Access Compliance Report

Public Rights-of-Way

(Curb Ramps)

Intersection ID: 22684	Main Street: OUTER_BRIDGE_LN	Cross Street: OXWYNN_LN	Location: NW
ADA ID: 82F2EEF3CD2B	Ramp Type: PerpDiag	Initial Pass/Fail: Fail	Overall Compliance: No
Severity Score: 26.25			
Codes/Mitigation Info/Possible Solution		Field Measurements/Component Compliance

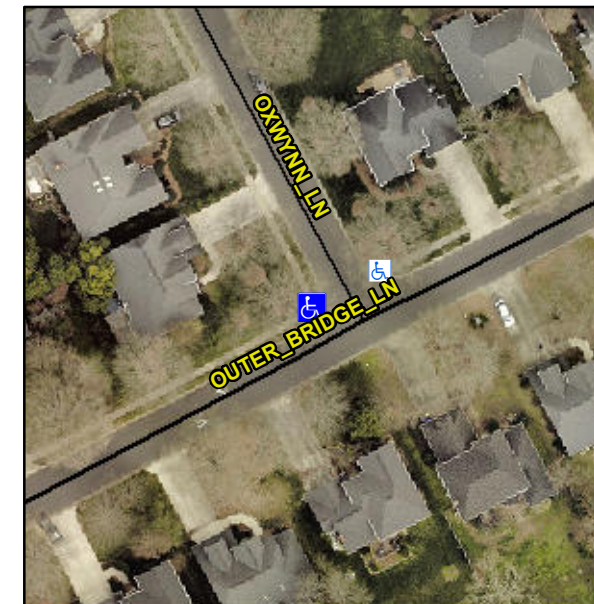
Not Found, R304.2.2, R304.5.3

Compliance	Description	Data	Compliance	Description	Data
N/A	Ramp Length (in)	45.0	No	Ramp Slope (%)	13.5
Yes	Ramp Width (in)	48.0	No	Ramp XSlope (%)	4.9
N/A	Flare Type LT	N/A	N/A	Flare Type RT	N/A
N/A	Flare Slope LT (%)	N/A	N/A	Flare Slope RT (%)	N/A
N/A	Flare Traversable LT?	N/A	N/A	Flare Traversable RT?	N/A
N/A	Landing Length (in)	N/A	N/A	DWS Provided?	N/A
N/A	Landing Width (in)	N/A	N/A	DWS Contrast?	N/A
N/A	Landing Slope (%)	N/A	N/A	DWS Length (in)	N/A
N/A	Landing X Slope (%)	N/A	N/A	DWS Full Width?	N/A
N/A	Landing Curb? (Y/N)	N/A	N/A	DWS Offset (in)	N/A
N/A	Shared Landing?	N/A			
N/A	Gutter Ponding?	N/A	N/A	Gutter Slope (%)	N/A
N/A	Gutter Lip Ht (in)	N/A	N/A	Gutter X Slope (%)	N/A
N/A	Painted X Walk1?	No	N/A	Painted X Walk2?	No
	X Walk 1 Direction	To S		X Walk 2 Direction	To E
N/A	X Walk 1 Width (in)	N/A	N/A	X Walk 2 Width (in)	N/A
	X Walk 1 Slope (%)	1.9		X Walk 2 Slope (%)	4.2
	X Walk 1 X Slope (%)	3.3		X Walk 2 X Slope (%)	2.3

N/A	Ramp inside XWalk1?	N/A	N/A	Ramp inside XWalk2?	N/A
	Road Slope (%)	1.9	N/A	Clear Space?	N/A
	Road X Slope (%)	5.5	N/A	Clear Space to XWalk (in)	N/A
N/A	Any Obstructions?	N/A	N/A	Storm Grate/Utility Hazard?	N/A
	Obstruction Type			Storm Grate/Utility Type	
		N/A			N/A
		Yes		Surface Condition? (G/P)	Good

Remove & Replace Curb Ramp With Two New Directional Ramps or Equivalent.
